**MUNICIPAL SERVICES CENTER, COUNCIL CHAMBER
3600 TREMONT ROAD**

BZAP Meeting Date: August 2, 2023

Subject: 3846 Waldo Place (VAR-37-23) - To allow the construction of a new two-story single-family residence that does not meet the City's residential design standards.

This memo serves as a summary of preliminary Staff comments regarding the July 24, 2023 submittal of Major Site Plan DEV-03-23 for the proposed construction of a two-story child day care center at 3230 Northwest Boulevard. Board of Zoning and Planning (BZAP) review of a site plan is required per UDO Article 4.05(M) of any project located within a commercial zoning district. The City's Technical Review Committee has met to discuss this application and comments have been compiled below for your review. These issues should be addressed and/or resolved in order to improve the prospect of project approval. This letter will be reviewed at the August 2, 2023 Work Session, and your team should be prepared to introduce the project to the Board and respond to each of the items noted.

ROOF PLAN

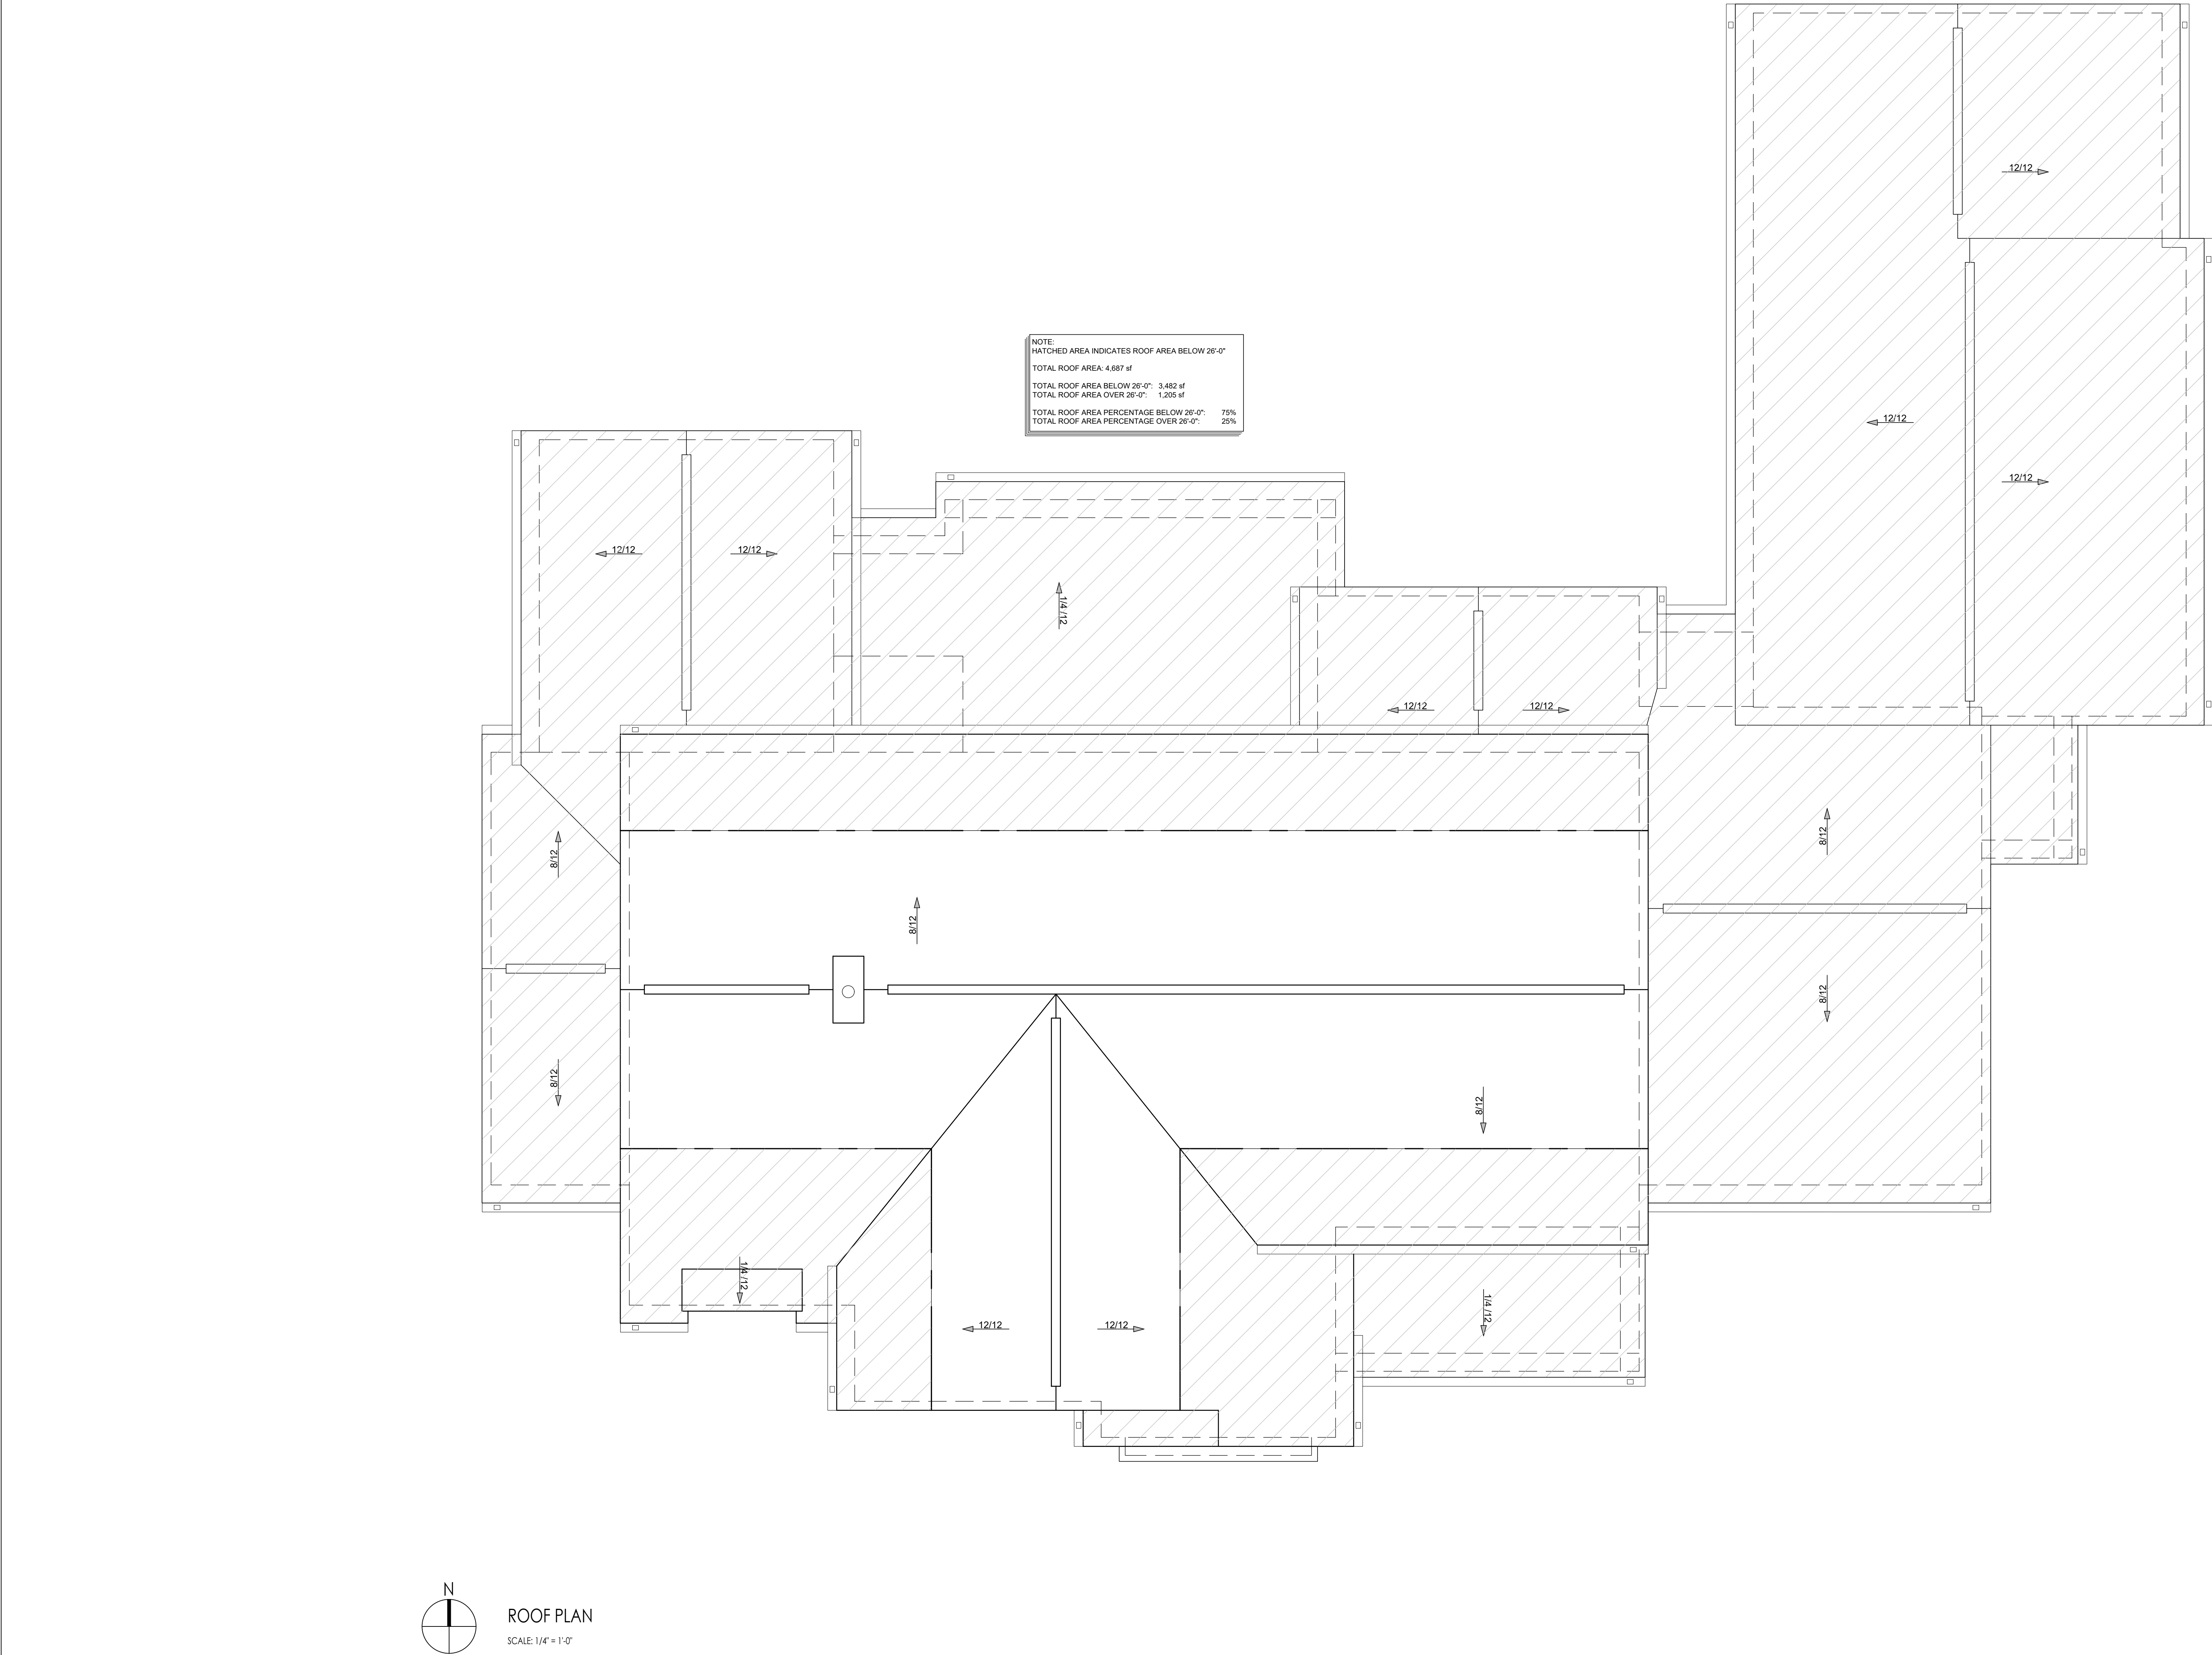
A revised plan was subsequently submitted by the applicant which further reduces the height from 32'-10" to 31'-10". The applicant has stated that they cannot go lower than what is presented. A more detailed landscape plan was also submitted.

SP1.1

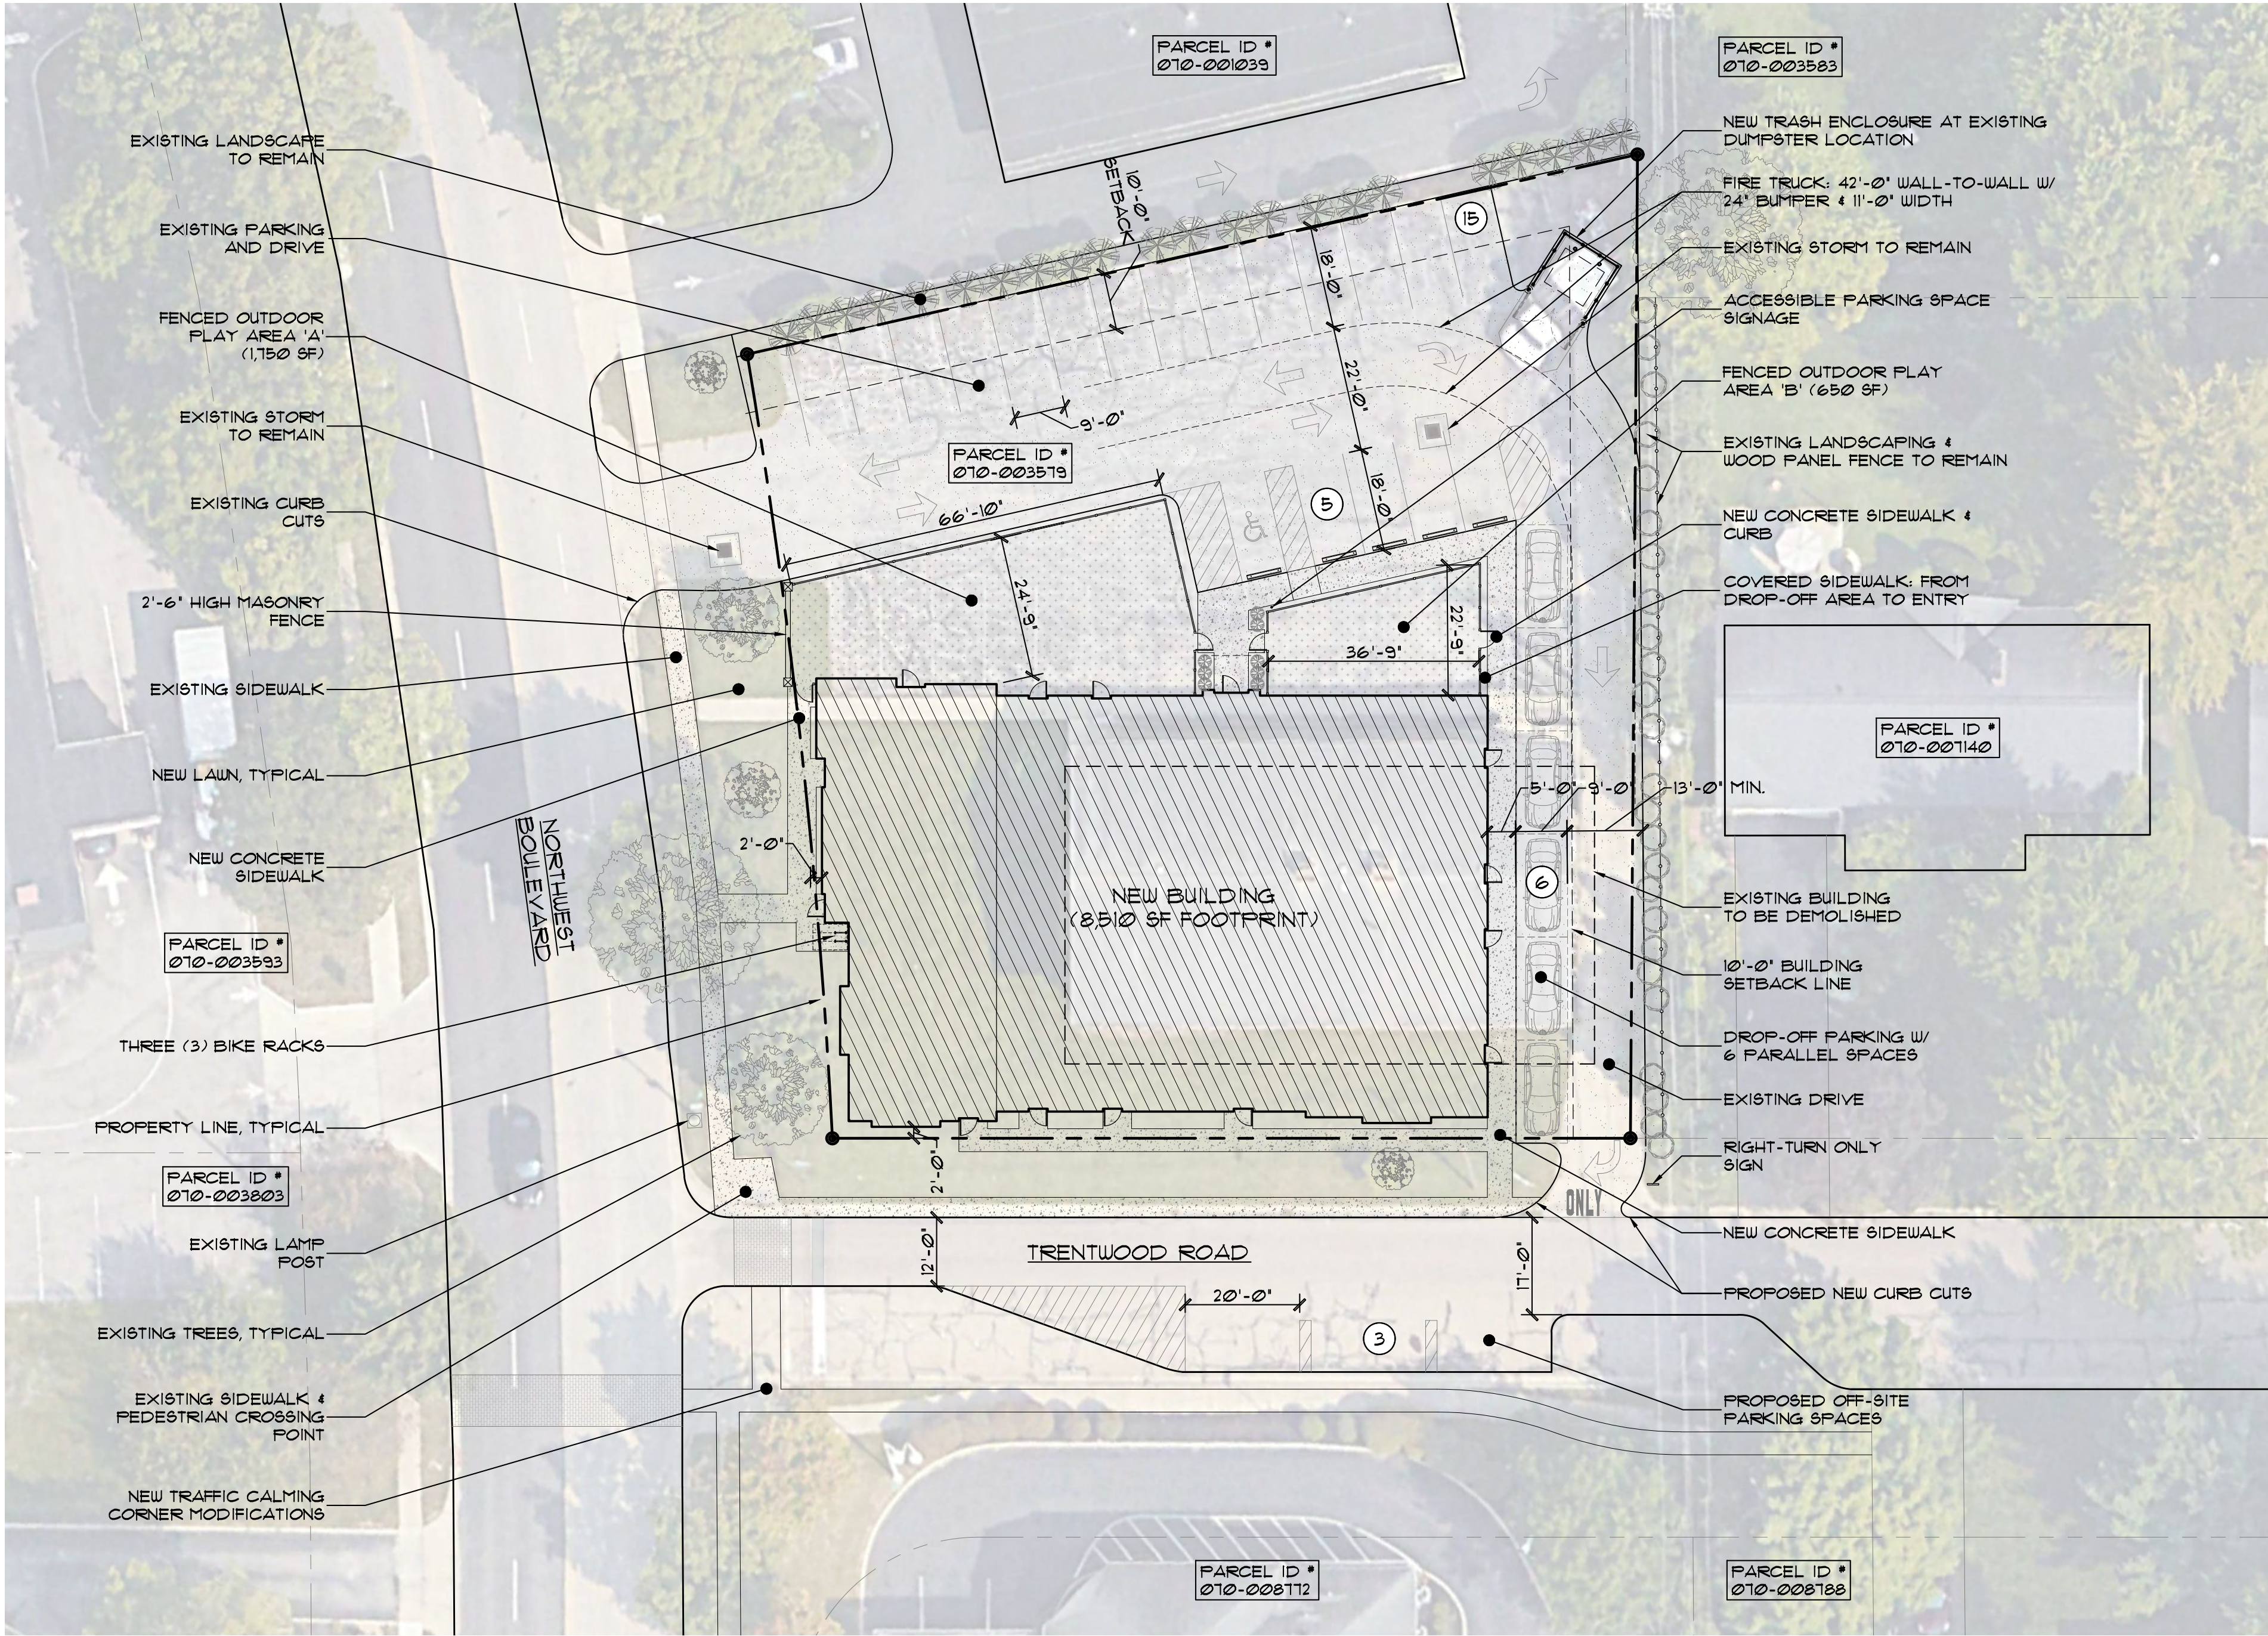
- 4) **Emergency Services** – A turning radius plan is needed to ensure the City's emergency vehicles can adequately access the site. More information is needed on whether the building will include a fire suppression and/or fire alarm system. Thank you for working proactively with the City on the proposed business name, as well as emergency event policies for staff.

- 6) **Traffic Management** – The City Engineer has approved the proposed site access and circulation pattern, and is also supportive of the three off-site parking spaces provided on the south side of Trentwood Road. Please continue to coordinate this potential improvement with the City's public works project and our plans. Please also investigate for any potential site visibility triangle obstructions.

- 7) **Parking** – Thank you for supplying additional information on the center's parking needs utilizing comparable examples. While a variance is needed, the information supplied appears to be sufficient. Should a parking problem arise, an off-site parking arrangement will be needed. Please note on the site plan where any shuttle buses/vans will be parked. Also, thank you for offering to allow after-hours parking for the City's future community center across the street at Kingsdale.
